# MARCO POLO - 101 W 33RD STREET

Date	Description
05.19.2022	Progress Set

1 UNIT PLAN - 1BD SHORT (TYPE B ADA UNIT - 1ST FLOOR ONLY)  
3/8" = 1'-0"

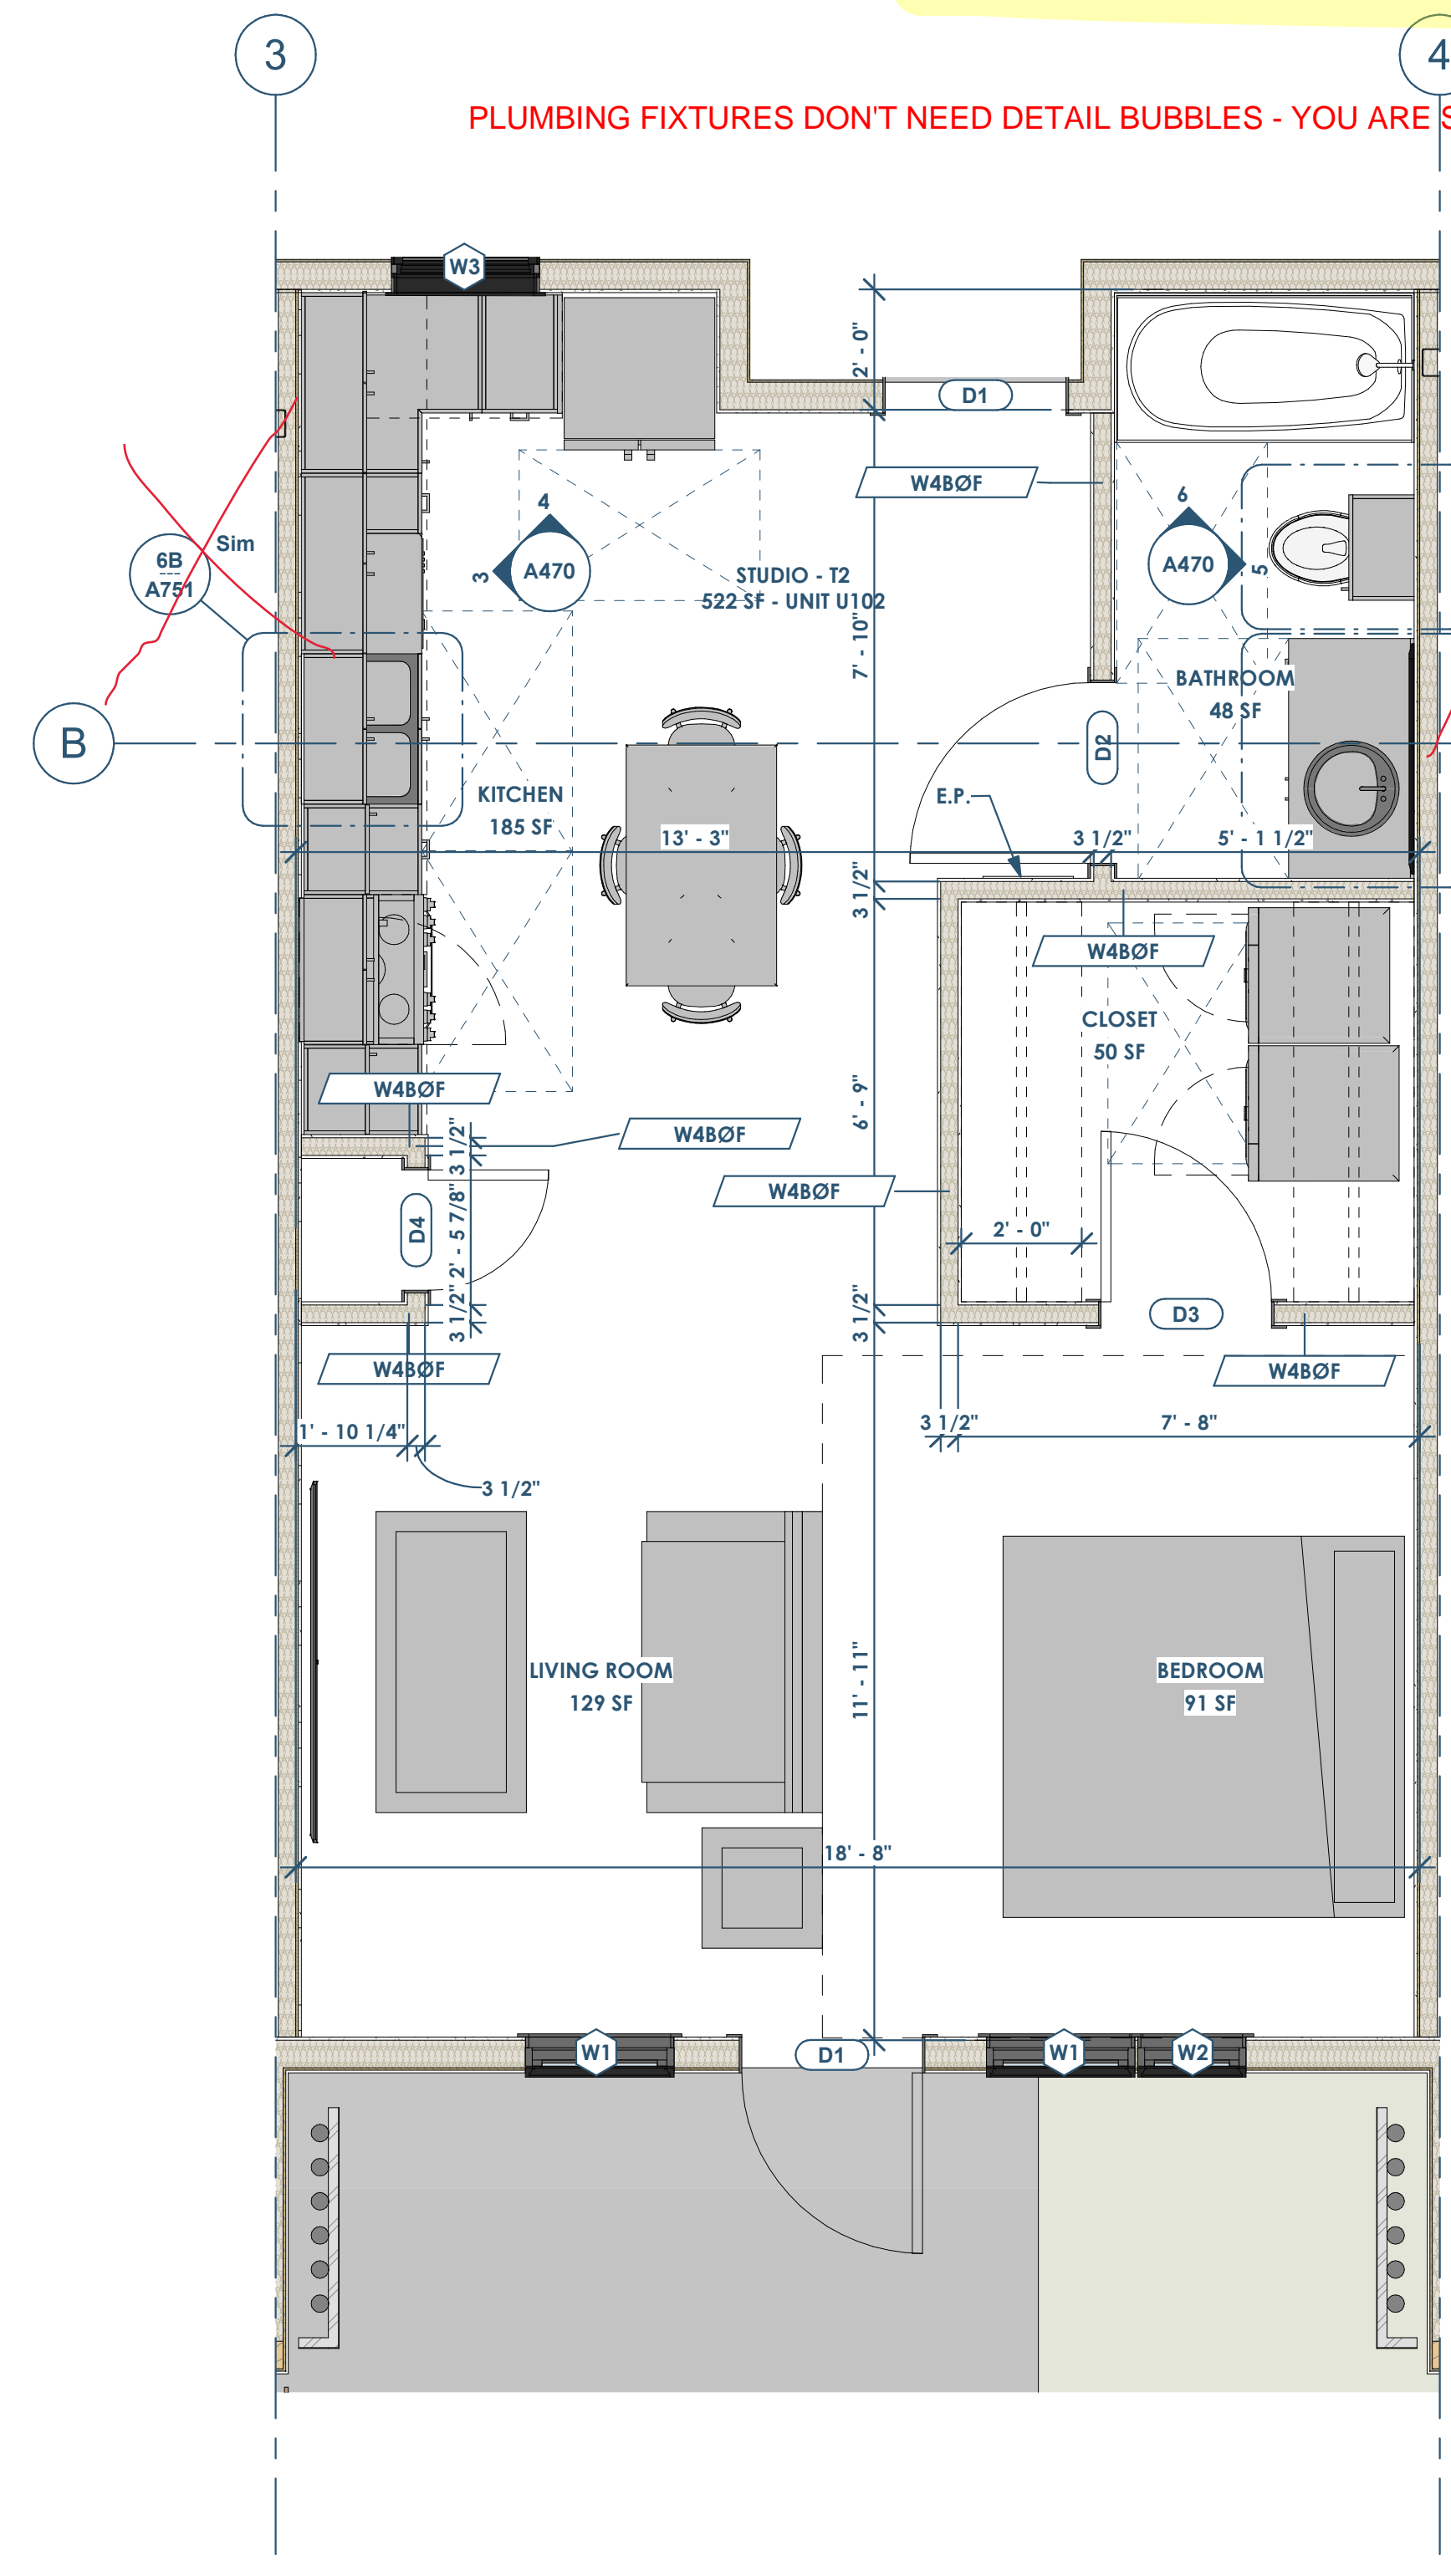
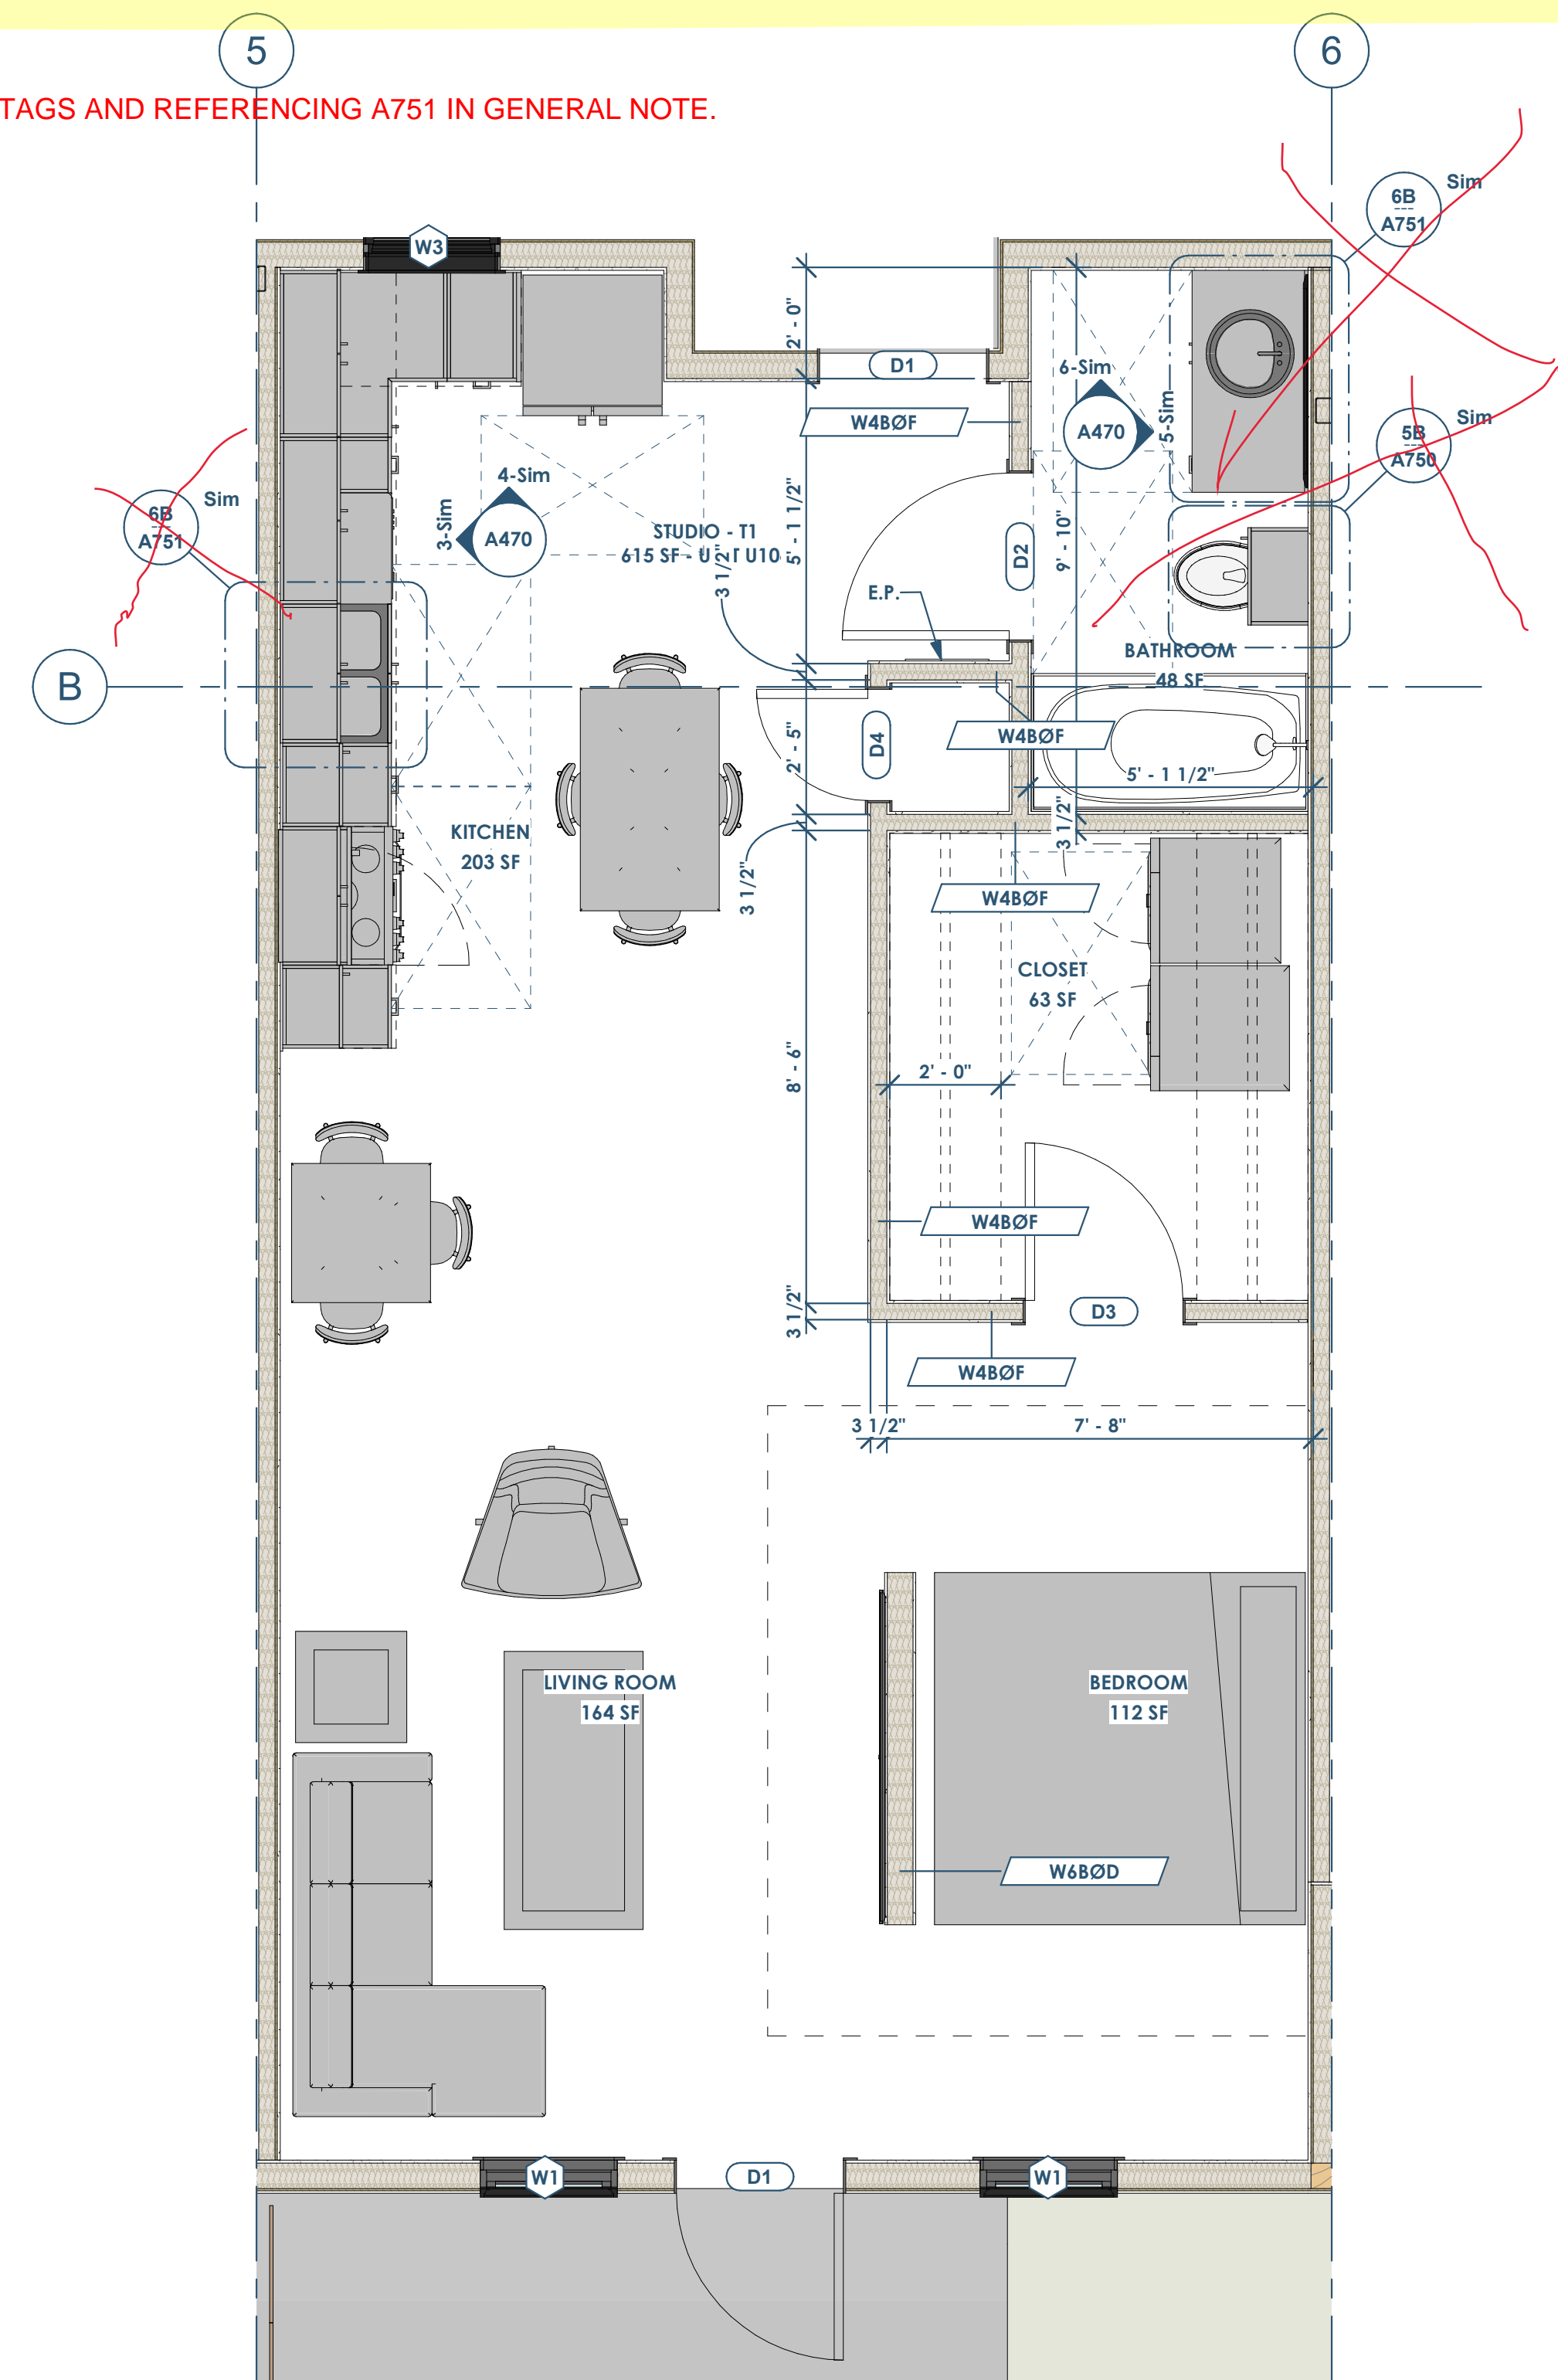
**ADD DIMENSION**  
**ADD REF. TAG FOR CLG. HEIGHT**  
**TYP. ALL ELEVATIONS**

REF. NOTES ON A101 FOR FLOOR PLAN DIMENSIONING; FURNITURE SHOULD NOT BE MORE PROMINANT THAN RELEVANT DIMENSIONS AND NOTES. CAN IT BE SHOWN LIGHTER OR DASHED?

PLUMBING FIXTURES DON'T NEED DETAIL BUBBLES - YOU ARE SHOWING ELEVATION TAGS AND REFERENCING A751 IN GENERAL NOTE.
